CS Memorandum No. 1702

Subject: Configuration Management Board Meeting No. 170

CMB Meeting Minutes #170

CENTRAL SUBWAY PROJECT
Project Trend/Change Control Log

CONTRACT NO. 1252
 DRAWING NO. RP-102
 FILE NO. 91,664
 REV. NO. 1P

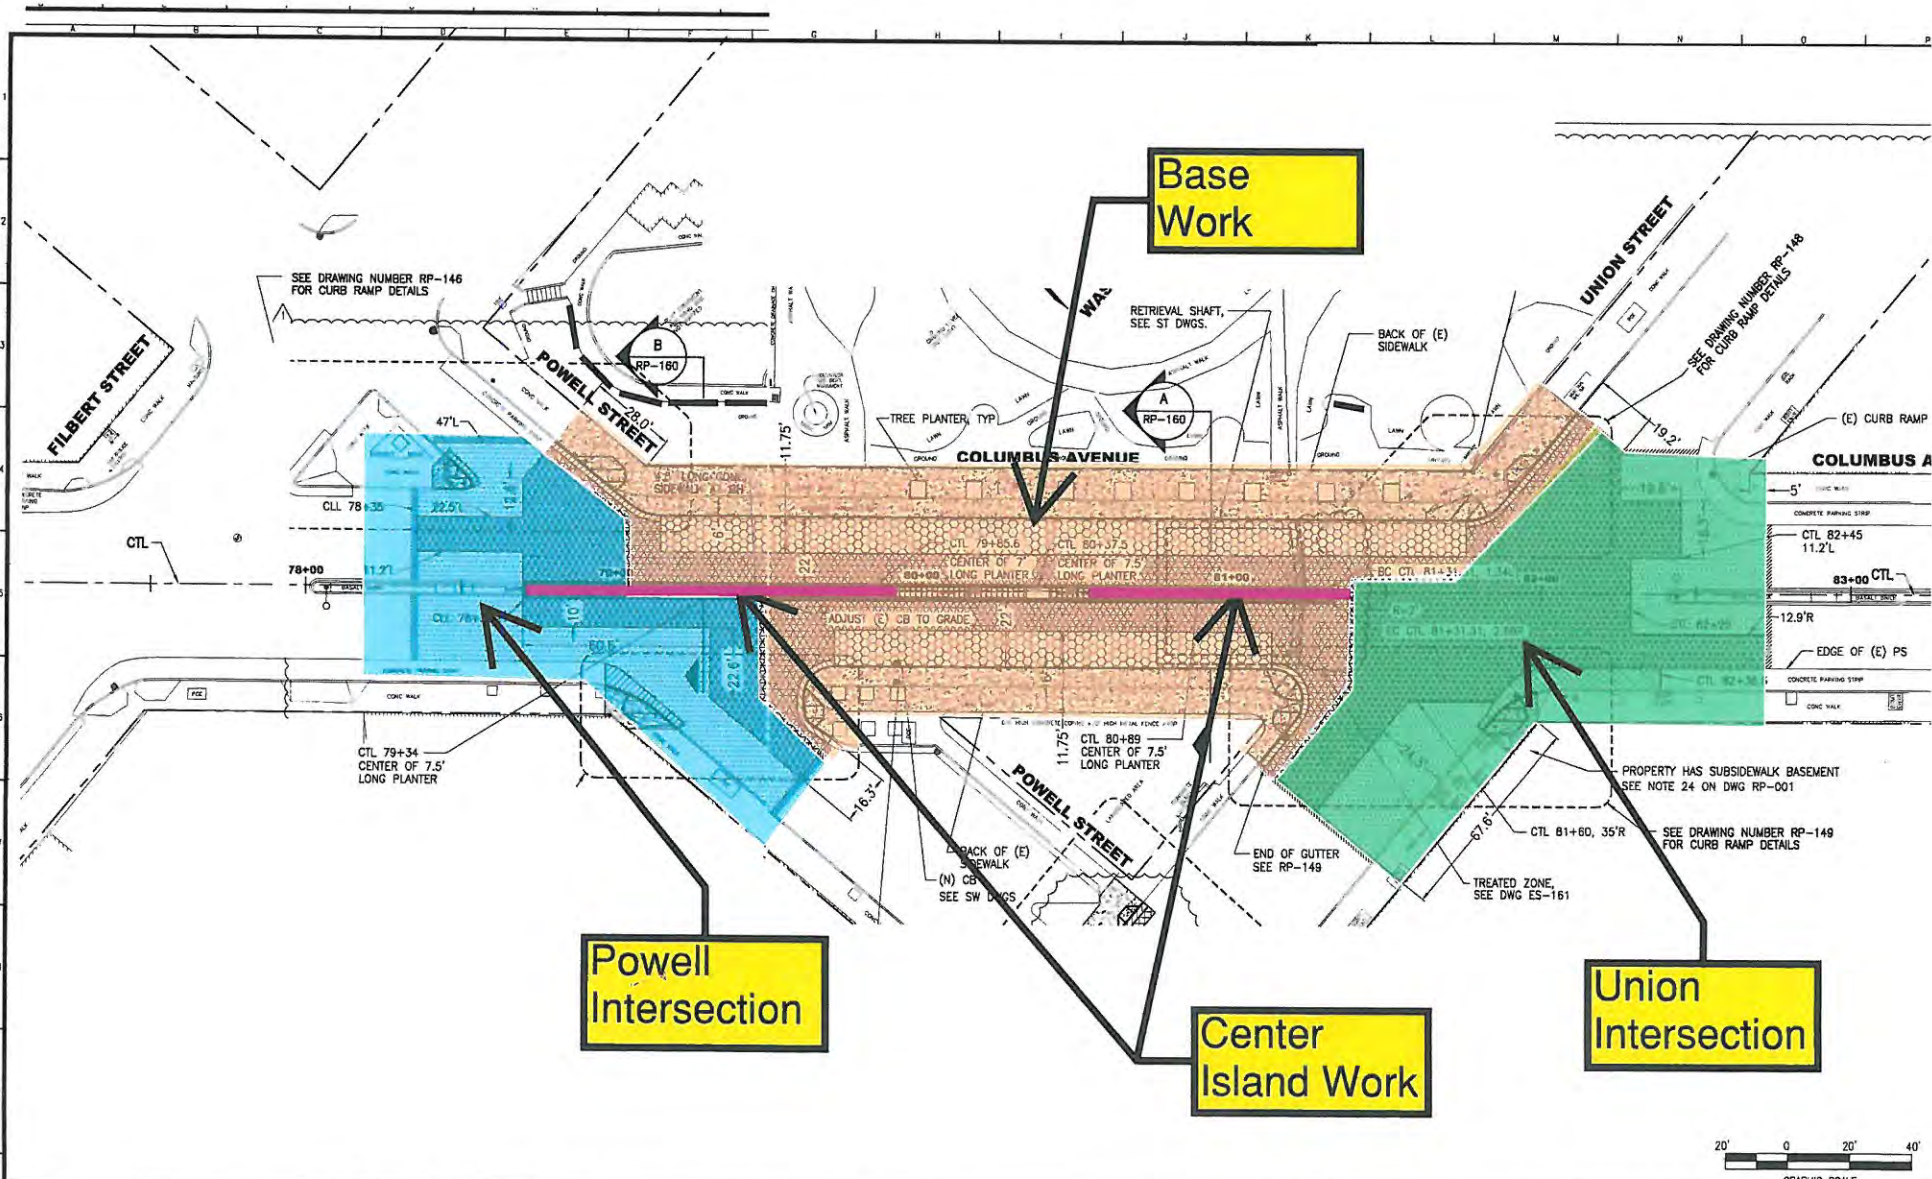
1. Spec. Reference:	GP
2. Drawing Reference:	WD-2733C , SW-1 , RP 101 & 102
3. What (Description):	Construct 15' wide sidewalks, x2 new reinforced bus pads, base and pave entire block. See Labor and Equipment Spreadsheet for Details:
4. Where (Location):	Union and Columbus
5. Why (Why a COR)	New street configuration
6. Conditions:	Excludes Police, PCO, Permits. Some equipment staging will be allowed on Filbert Street, some street base lanes will have longer working hours to allow concrete to cure (12hr shift). Bus pads, Sidewalks, and Islands will be barriered off for work and will allow 7am-6pm work shift behind barrier. All traffic/pedestrian control by police and PCO.
